Transmittal Form: Plat Paper Check

Re: Woodburn Subdivision Final Plat App
FSUB 22-01 Smith Creek Phase 4A /
plat Smith Creek P.U.D. 8 (County
SP24-001 "Smith Creek P.U.D. 8")
related to City master/parent land use
case file no. ANX 2017-05

SMITH CREEK P.U.D. 8

SHEET 1 OF 7

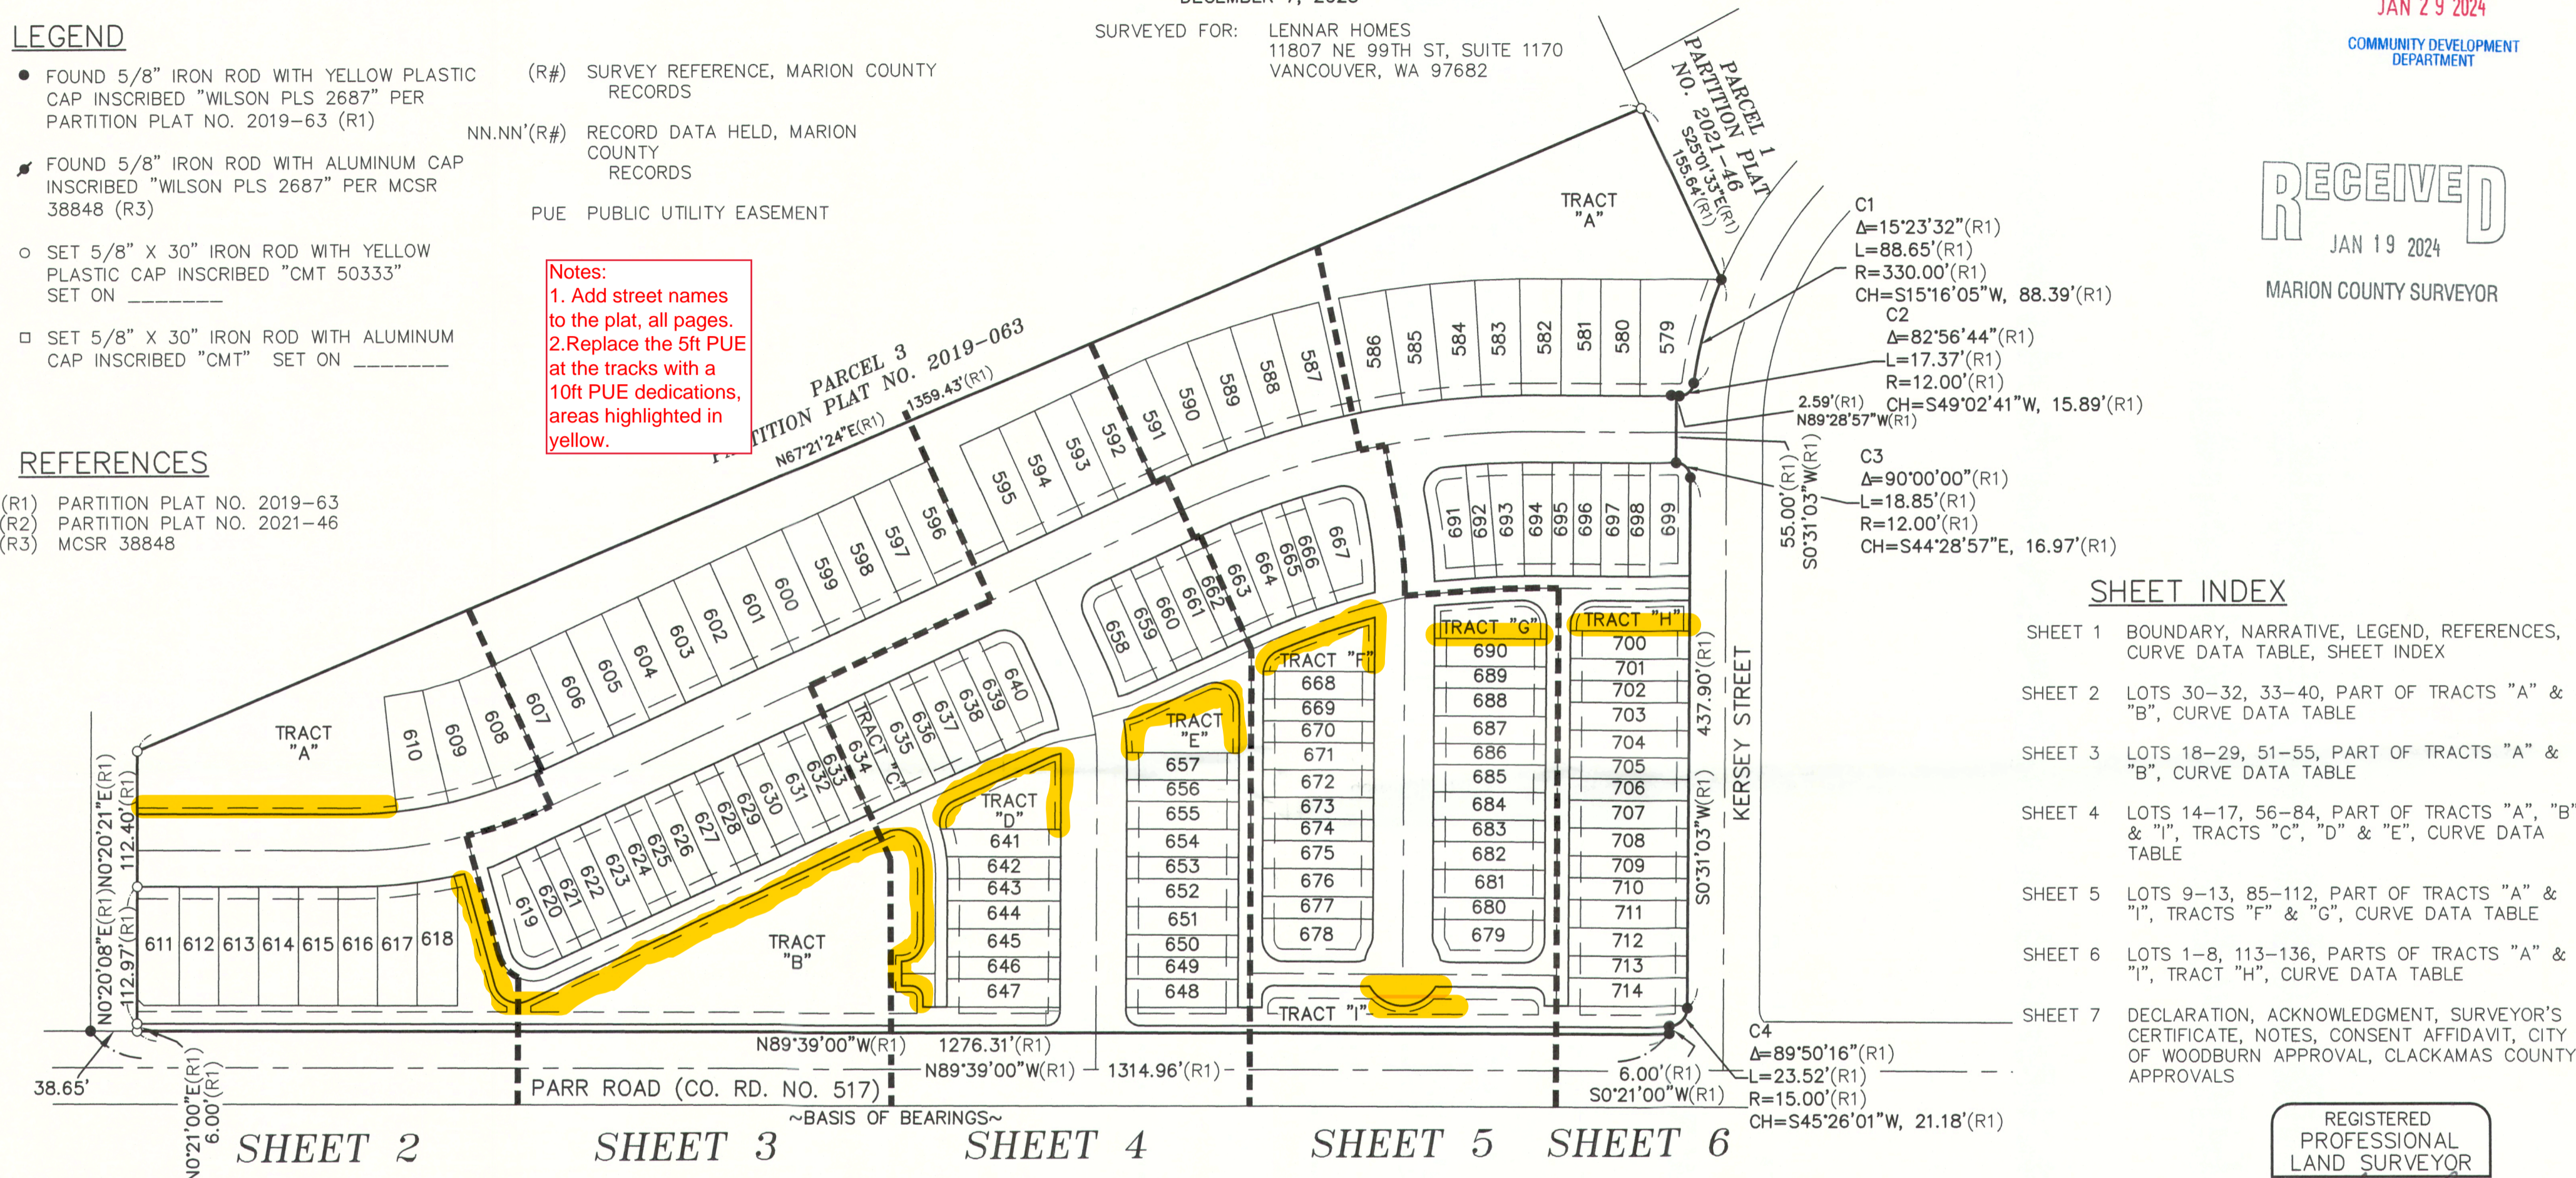
Notes:
 1. Add street names to the plat, all pages.
 2. Replace the 5ft PUE at the tracks with a 10ft PUE dedications, areas highlighted in yellow.
